## RESPONSE TO REQUEST FOR ADDITIONAL INFORMATION

### US-APWR Design Certification

Docket No. 52-021

**RAI NO.:** NO. 1050-7218 REVISION 3  
**SRP SECTION:** 03.07.02 – Seismic System Analysis  
**APPLICATION SECTION:** 3.7.2  
**DATE OF RAI ISSUE:** 08/30/2013

Figure 1 R/B Complex Contact Pressure Contours – Sliding is Allowed, but Separation is Not Allowed at the Foundation Subgrade Interface. Dark Blue Color Indicates the Area of the Interface that is in Tension (about 18% of total basemat surface).

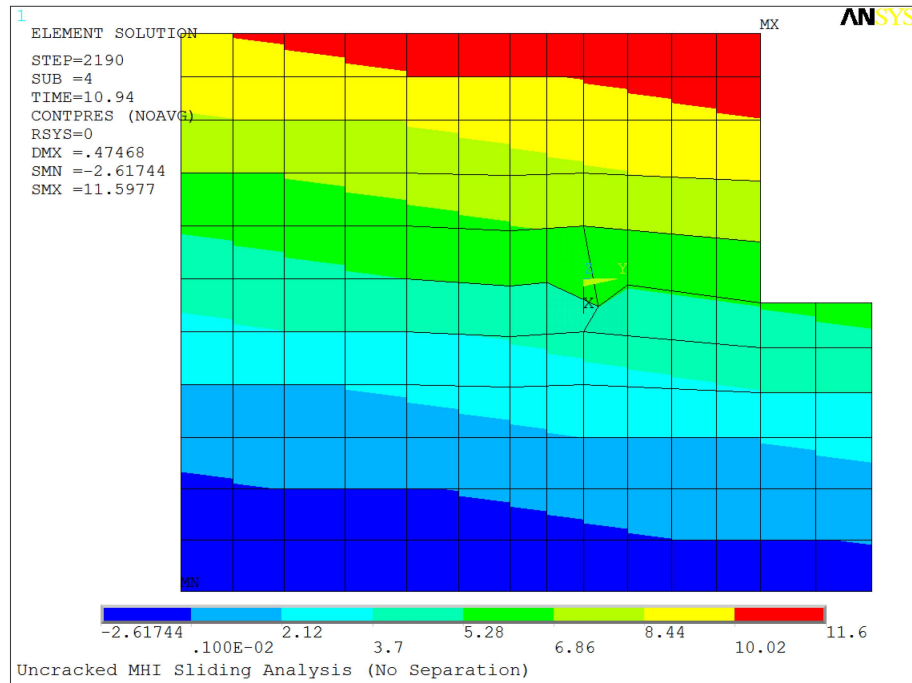
The staff requests the applicant to describe how the potential for uplift of the foundation basemat from the underlying soil/rock was evaluated for the generic cases considered. In addressing this, for each case considered, quantify the minimum area of the basemat that remains under compression at all times during the transient response (considering the simultaneous effect of the three design-basis ground motions and all applicable gravity loads), as a percentage of the total basemat area. In evaluating potential uplift, assess the acceptability of the uplift relative to acceptable engineering practice. An acceptable method for assessing the potential for basemat uplift is described in SRP (Rev 4), Section 3.7.2.

The contact pressure contours calculated at time instant T = 10.9 seconds are presented in Figure 1. The minimum contact area ratio was calculated “using the minimum basemat area that remains in compression with the soil” (Reference 2) and was found to be 82%. This satisfies the minimum 80 percent requirement as indicated in SRP 3.7.2 Acceptance Criteria II.4 Revision 4. It is therefore concluded that the linear SSI analysis methods used for US-APWR standard plant are acceptable.
